SUBJECT: REQUEST FOR ADDITIONAL INFORMATION ON THE DRAFT WASTE INCIDENTAL TO REPROCESSING EVALUATION FOR VITRIFIED LOW-ACTIVITY WASTE DISPOSED ONSITE AT THE HANFORD SITE (DOCKET NUMBER PROJ0736)

**Request for Additional Information
Draft Waste Incidental to Reprocessing Evaluation for
Vitrified Low-Activity Waste Disposed Onsite at the Hanford Site, Washington**

Data from Table 2-3 in the draft WIR evaluation

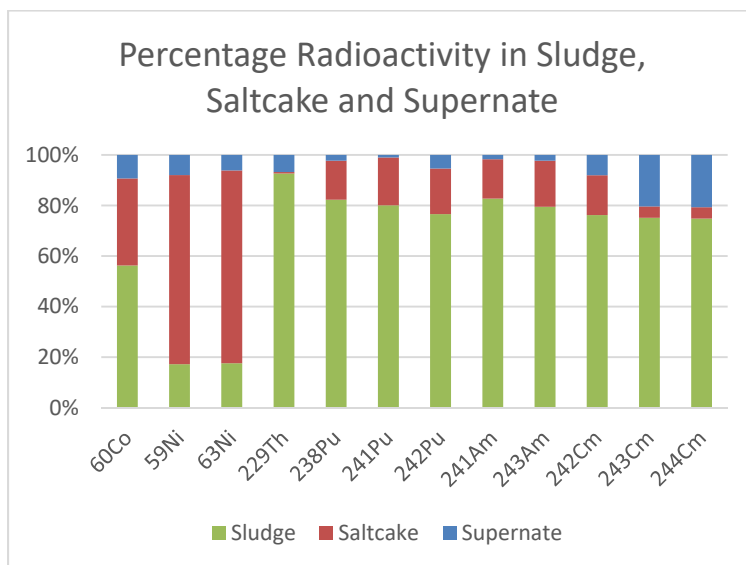
Table 3-29 in the PA document lists the wastefrom distributions resulting from the five cases considered to potentially be disposed of in IDF for 11 of the 25 key radionuclides identified by DOE. The 14 key radionuclides that are not listed in Table 3-29 are ^{60}Co , ^{59}Ni , ^{63}Ni , ^{228}Rn , ^{229}Th , ^{232}Th , ^{238}Pu , ^{241}Pu , ^{242}Pu , ^{241}Am , ^{243}Am , ^{242}Cm , ^{243}Cm , ^{244}Cm . (Note that ^{233}U and ^{235}U are listed in Table 3-29 but they are not listed as a key radionuclide in the draft WIR evaluation.)

In Table 2-3 of the draft WIR evaluation DOE lists the estimated total radioactivity in the 177 underground waste tanks, broken down by how much radioactivity is in the supernate, saltcake, and sludge for certain radionuclides (Note that key radionuclides ^{228}Rn , ^{232}Th are not listed in Table 2-3 of the draft WIR evaluation). For 12 of the 14 key radionuclides that are not listed in Table 3-29, Table 2-3 of the draft WIR evaluation shows that there is some percentage of these radionuclides that remains in the supernate or saltcake. For example, more than 80% of the ^{59}Ni and ^{63}Ni is in the saltcake or supernate, and about 45% of the ^{60}Co is in the saltcake or supernate. About 20-25% of the ^{238}Pu , ^{241}Pu , ^{242}Pu , ^{241}Am , ^{243}Am , ^{242}Cm , ^{243}Cm , and ^{244}Cm are not in the sludge. In the draft WIR evaluation, DOE states that ^{59}Ni is present in very low concentrations in the vitrified LAW and is an insignificant contributor to dose after IDF closure. However, it is unclear what percentage of these radionuclides may be present in the various waste forms that will be disposed of at IDF and what was removed by processing.

Please provide the percentages of key radionuclides removed for those key radionuclides (see Table 4-3 of the draft WIR evaluation) that are not already included in Table 3-29.

I-129 Distribution across Waste Forms as % of BBI by Case (Adapted from data in Table 3-29 of the PA)

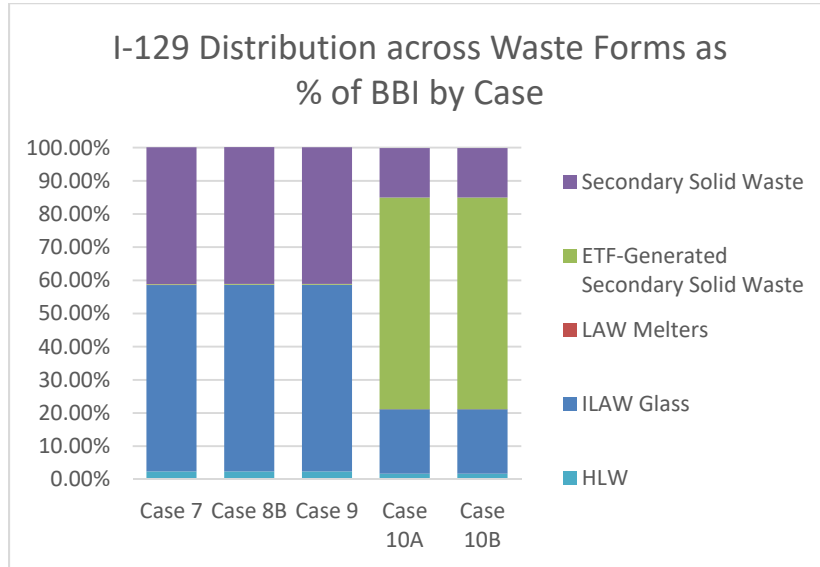
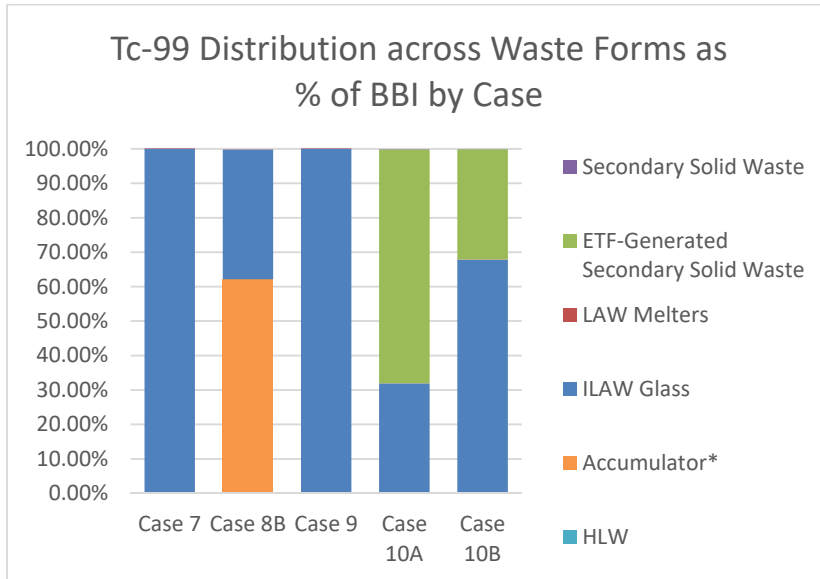
Table 3-29 in the PA document provides the summary of radionuclide inventories and wastefrom distributions for five cases. As shown below, the majority of the ⁹⁹Tc and ¹²⁹I does not remain in the HLW tanks. In Case 7, Case 8B, and Case 9, about 40% of the Best Basis Inventory (BBI) of ¹²⁹I ends up in the Secondary Solid Waste (SSW). In Case 10A and Case 10B, nearly 80% of the ¹²⁹I ends up in either the Effluent Treatment Facility-Generated (ETF-Generated) SSW or the SSW. A negligible amount of the ¹²⁹I remains in the HLW in any of cases.

In Case 7, over 99% of the ⁹⁹Tc is assumed to end up in the Immobilized Low-Activity Waste (ILAW) glass. In Case 8B, as a result of removing ⁹⁹Tc from the LAW off-gas stream, 16,500 Ci of ⁹⁹Tc accumulates over the course of the waste treatment and immobilization plant mission. The footnote on Table 3-29 states that “these curies would likely be processed in High-Level Waste and would not end up at the IDF”. In the PA document, DOE further describes Case 8B as follows: “a ⁹⁹Tc removal unit operation has been added after the submerged bed scrubber (SBS) wet electrostatic precipitator (WESP) to remove ⁹⁹Tc at an efficiency of 99% from the LAW liquid off-gas steam prior to being recycled back to pretreatment. This inventory would not be disposed of at IDF and represents the lower range of ⁹⁹Tc inventory in glass and grout waste forms.”

Please provide additional information on the percentage of ⁹⁹Tc and ¹²⁹I that is expected to be recycled back to the DFLAW feed, percent returned to the tank farm to be disposed of as HLW, and percent purged via the Effluent Management Facility (EMF) evaporator concentrate.

Please provide additional information about the accumulator mentioned in Table 3-29 of the PA document. Please specify if the ⁹⁹Tc is assumed to be accumulating in one component or in multiple parts of the waste treatment plant (WTP). Please provide the hypothetical plan for disposal of the accumulator waste under this scenario.

Figure 4-22. Two-Dimensional Vertical Cross-Section Model of Integrated Disposal Facility Showing Numerical Grid and Surface Barrier Materials.

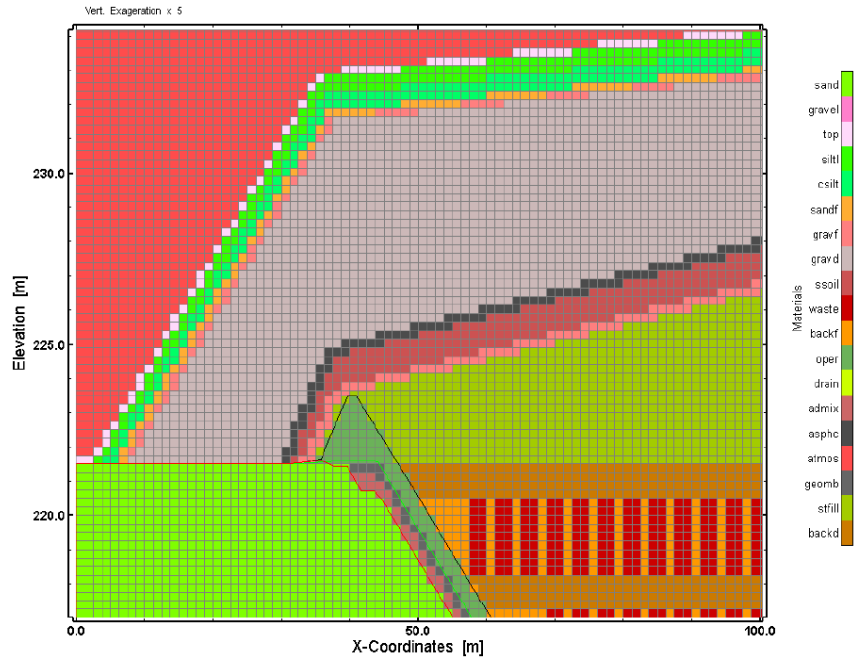
Figure 4-22 from the PA document (shown below), provided the numerical grid and material properties assigned for near-field flow. It appears that some layers are not continuous in the model. It is not clear how the discretization was fine enough to ensure proper precision. The text of the PA document describes the stair-stepped discretization but does not explain how it was determined that the model discretization was sufficient. The potential impact is shown in Figure 5-11 from the PA document (partial figure provided below) where the saturation values and liquid flux rates appear to have large variations as a result of the numerical grid selection.

Please provide additional basis for the discretization of the numerical models used in the PA to simulate near-field flow, release, and transport. Demonstrate that the simulated releases were not artificially biased by the stair-stepped grid representation of the slopes of the engineered

cover and liner system. Provide a basis for the amount of increase, at the limit, on the FRR's from the glass as a function of refined numerical grids for release, and how the model should appropriately account for the uncertainty of a coarser numerical grid.

Figure 5-11. CLD3-Infiltration: 33.0 mm/yr. Spatial Distribution of Saturation (Top) and Magnitude of Water Fluxes (Middle), and Vertical Fluxes (Bottom) at 750 Years [After Cover/Liner Degradation].

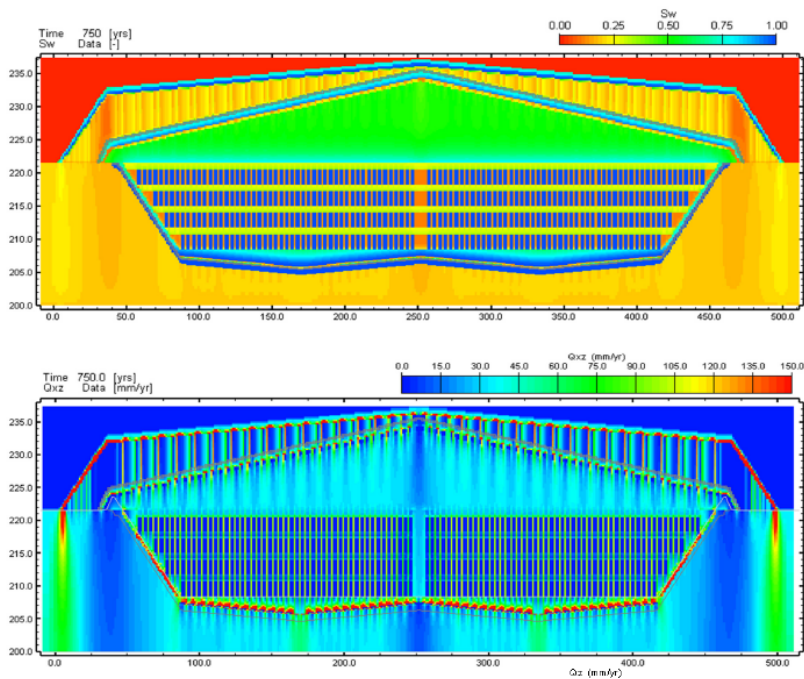
DOE described the discretization of the model for glass degradation on page 5-49 of the PA document. An attempt was made to strike a balance between computational time and accuracy. Modeling with a 2 cm by 2 cm grid spacing resulted in execution times of over a month per simulation. The resultant fractional release rate (FRR) from the glass was 26% higher than the coarser grid, which DOE did not believe was significant in the context of performance assessment uncertainties. A 2 cm grid spacing is extremely coarse to represent the processes occurring at the glass/engineered system interface. Layers that are tens of microns thick can significantly influence the ingress and egress of species at the interface. With only two data points with respect to the influence of grid discretization, it is unknown how much the FRR's will increase as the grid spacing is further refined and at what point further refinement will have a minimal impact.

Figure 5-1. Grids for Alternative Disposal Configurations Involving One Waste Package or Four Vertically Stacked Waste Packages.

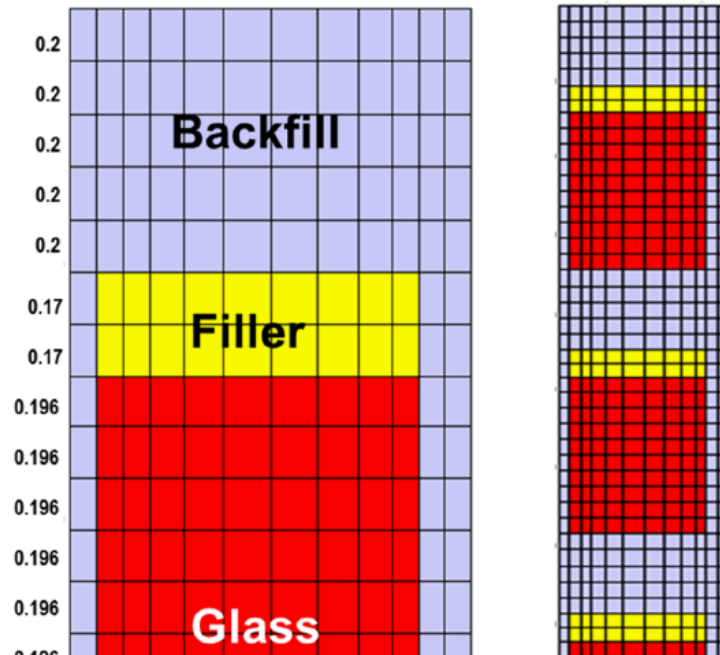
Throughout the PA document (for example page 5-19), DOE indicated that highly permeable layers, such as the drainage layers, act as capillary barriers under most conditions. In addition, Table 5-14 showed that the simulated flux of water through the wastefrom is approximately ten times less than the infiltration rate. Adequate model support was not provided for the simulated capillary barrier effects provided by the modeling. The figure below (Figure 5-1 from RPP-CALC-61031) show the coarse discretization and discrete layers used in the near-field modeling. It isn't clear how much of the observed reduction in flow through the wastefrom is a result of the modeling approach selected.

In the real system, a fractured glass surrounded by soil will have some of the fine-grained soil that infills the fractures at the boundary of the glass (NRC notes that the glass is contained in a stainless steel canister and DOE has elected to ignore the effects of the canister). When finer-scale modeling is used, water that flows along the surface of the unfractured glass will enter the fractures and saturations can build up locally resulting in dynamic rivulets of flow which otherwise would not be observed in the coarse-scale modeling with large timesteps. In addition, the MCC parameters have natural variability which is not represented in the DOE modeling approach where uniform properties are prescribed for every cell of a given material type. Modeling of the capillary barrier effect using heterogeneous properties showed much earlier breakthrough of moisture than would be estimated using homogeneous properties (Ho and Webb, 1998).

Please provide information that demonstrates that the numerical grids used for near-field flow were sufficient to evaluate performance. This could include performing numerical modeling of near-field flow and transport using refined spatial and temporal representations with natural heterogeneity. . Please provide additional support for the numerical model results.

Figure 4.6. Sodium Ion Exchange Rate vs. Reciprocal Temperature for LAWABP1 Glass (McGrail et al. 2001a)

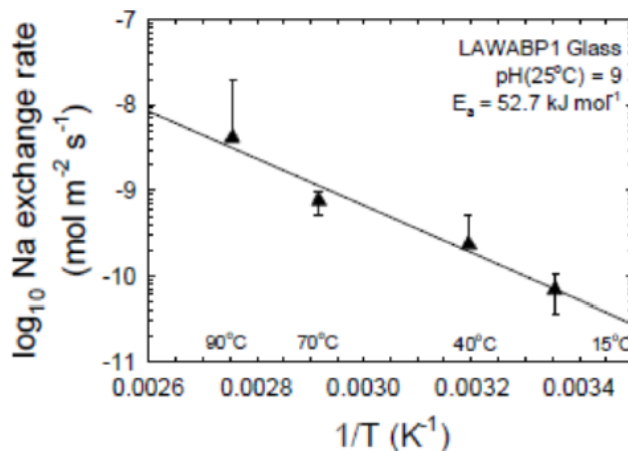
The figure below from PNNL-24615 shows the empirical data for determining the sodium ion exchange rate for LAWABP1 glass. The value was estimated to be 5.3×10^{-11} mol/m² s by extrapolating the data to 15 °C and assuming the value was constant in the PA (draw a line horizontally from the best fit slope at 15 °C to the y-axis). The fractional release rates are sensitive to this parameter and based on the four data points, their uncertainty, and the extrapolation of the data the basis provided by DOE was not adequate for fixing this value as a constant.

Please address the treatment of the uncertainties described in the basis portion of this comment with respect to development of glass fractional release rate expressions for the PA. If necessary, revise the expressions and generate new PA results that reflect the full range of uncertainty in the glass degradation rates. NRC staff understands that a variety of sensitivity cases were examined by DOE for various uncertainties associated with glass degradation. However, most of those examinations were one-at-a-time evaluations that can be mathematically compounded but may not yield a fair assessment of the importance of these uncertainties combined with other uncertainties raised by this RAI package. If appropriate, the expressions used in the system model uncertainty analyses should be revised.

Figure 4.7. Normalized Glass Dissolution Rate, Based on Boron, as a Function of pH(T) for LAWA44 (from Pierce et al. 2004).

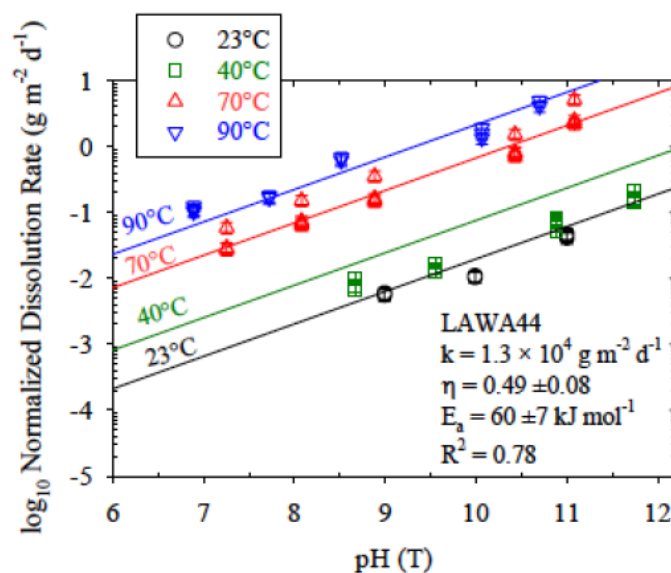
Figure 4-7 from PNNL-24615 has a relatively poor fit of the data at 40 °C, which impacts the uncertainty assigned to the coefficients. When NRC staff attempted to use a broader range for activation energy in the FRR regression equations in order to understand the significance of the uncertainty the expression yielded non-physical results. Table 4-1 from PNNL shows the derived parameters for the different glass compositions. As implemented in the PA, the three most important parameters (the forward rate constant (k_o), the glass apparent equilibrium constant (a), the Na ion-exchange rate (r_{EX})) were all fixed as constants. Even if the previously discussed shortcomings are dismissed, some of the derived parameters have R^2 of only 0.78 on a logarithmic scale.

Figure 3-62. Plan View Comparison of Central Plateau and Integrated Disposal Facility Geologic Framework Models at Long-Term Steady-State Water Table (119.5 meters).

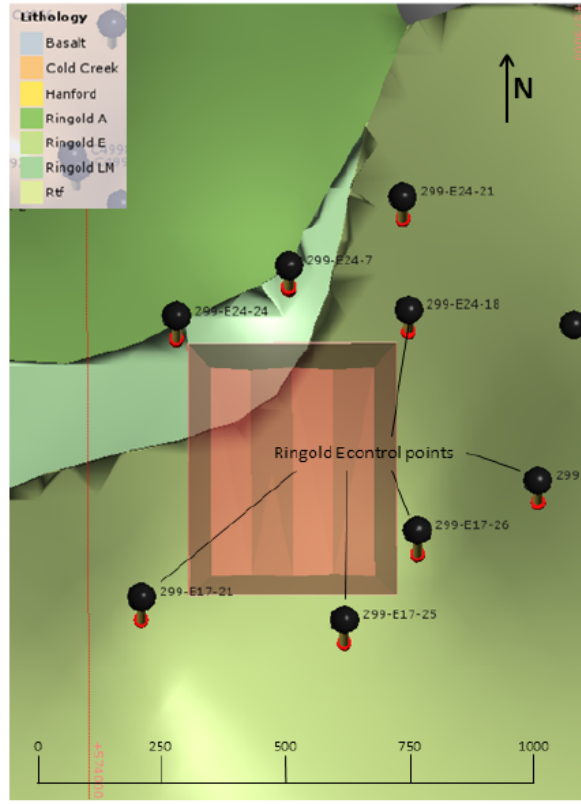
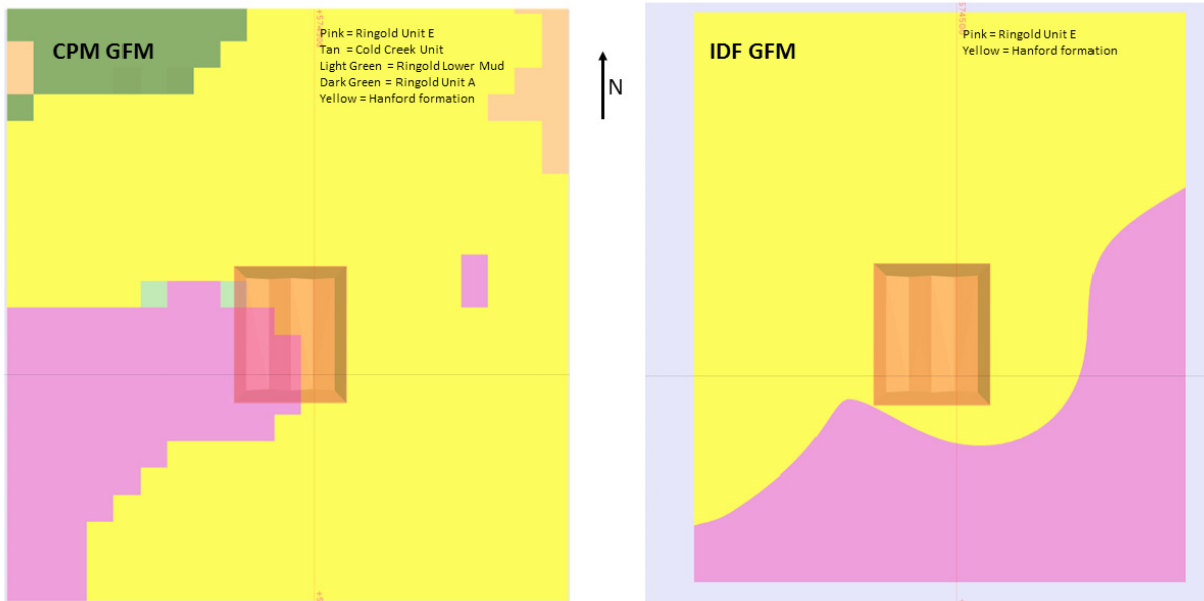
DOE's previous interpretation of the geology underlying the IDF had a layer termed the Ringold E present in the northwest corner of the footprint of the facility (see the figures below). DOE explained that some geologic information was reinterpreted, and the geologic framework model was revised. The data shows quantitative information to suggest the boundary of the layer is somewhere between the boreholes (see first figure below). If the modeling was revised, it isn't clear how the change in the boundary of the unit was validated in the absence of additional data. The significance of the unit is that the Ringold E is much less permeable than the Hanford unit such that fluxes of contaminants into the unit experience lower dilution and therefore result in higher concentrations. If groundwater protection standards apply to all geologic units, then it may be more difficult to demonstrate that groundwater protection standards have been met.

Please provide additional basis for the reinterpretation of the location of the Ringold E and indicate whether groundwater protection standards apply to this unit.

Figure 4-56. Fitted Log-Normal Distribution to the van Genuchten “Alpha” Parameter Dataset Used for the H2 Unit.

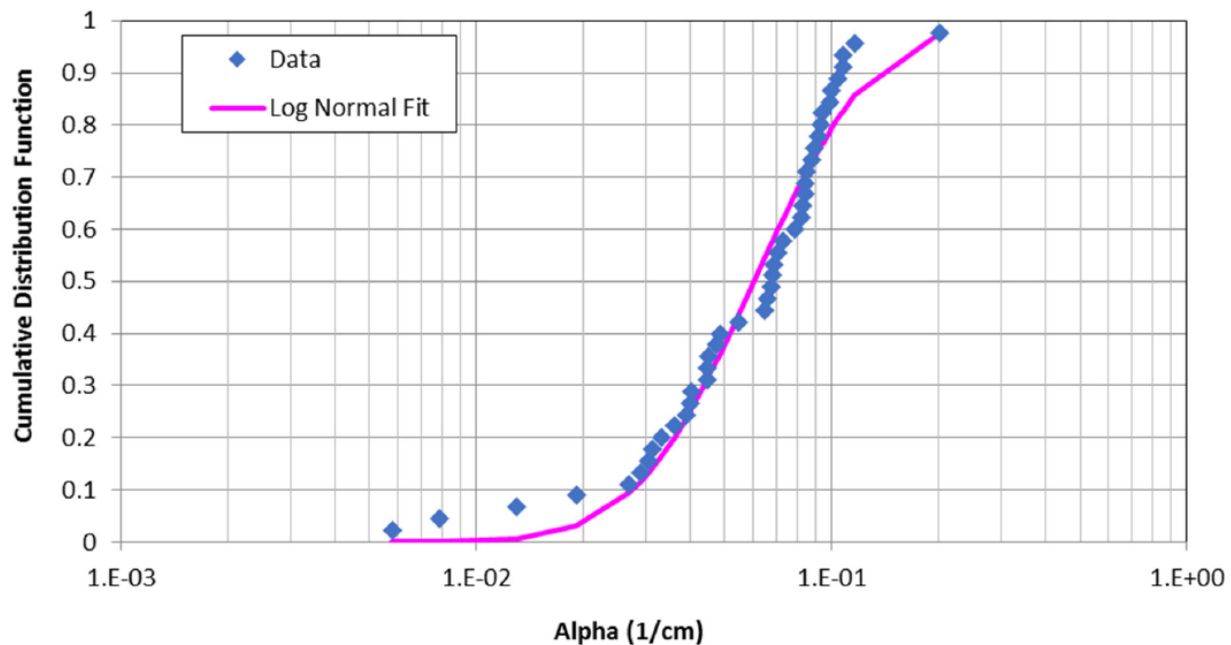
To develop uncertainty distributions of unsaturated flow parameters the empirical data were fit with statistical distributions. The van Genuchten alpha parameter for the H2 unit was assigned a log-normal distribution. The fit of the equation to the data showed deviations at the tails of the distributions (See Figure 4-56 from the PA document provided below).

Please discuss the implications of the deviation in the fitted distributions from the underlying data.

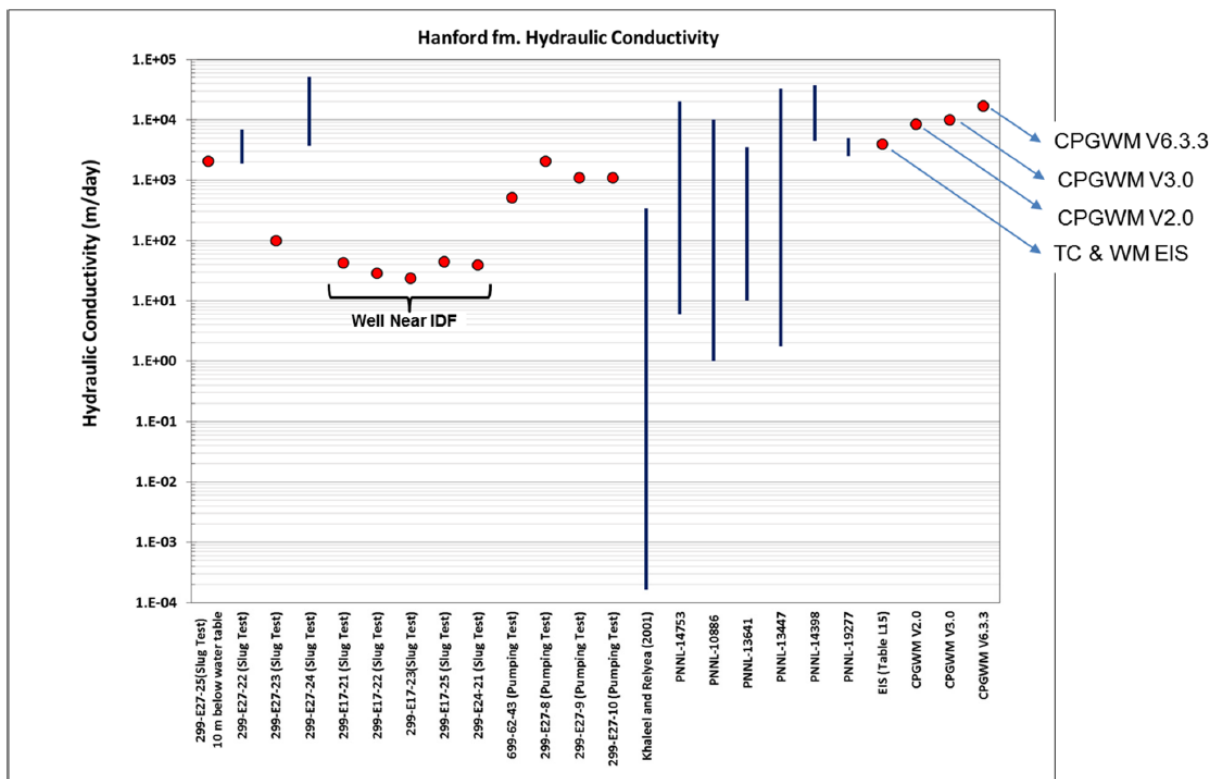
The changes to the estimated hydraulic conductivity values for the saturated zone over time suggest the base case value best estimate may not be reliable.

The saturated zone hydraulic conductivity, or rather the product of the saturated zone hydraulic conductivity and the gradient, is a key factor with respect to the reduction of risk at the Hanford site. Flux rates of water through the unsaturated zone are relatively low whereas the flow rate of water through the saturated zone are comparably high. This creates a large dilution effect on contaminant fluxes thereby reducing risk to an offsite receptor. DOE has investigated the saturated hydraulic conductivity over numerous decades and produced the very detailed figure (Figure 4-94 in the PA document) shown below. The figure highlights two important features. First, that the local values can deviate significantly from the global values and secondly, that the estimated values have been highly volatile over time. Since completion of the TC & WM EIS the values have increased almost an order of magnitude. While the specific discharge values may have increased by a lesser amount than estimates of the saturated zone hydraulic conductivity, it isn't apparent why the base case value is thought to be reliable and unlikely to change given the past changes as more data has been collected and additional modeling has been completed.

Please discuss confidence building activities to support the base case saturated zone hydraulic conductivity values assigned. Please discuss plans to verify the base case saturated zone hydraulic conductivity.
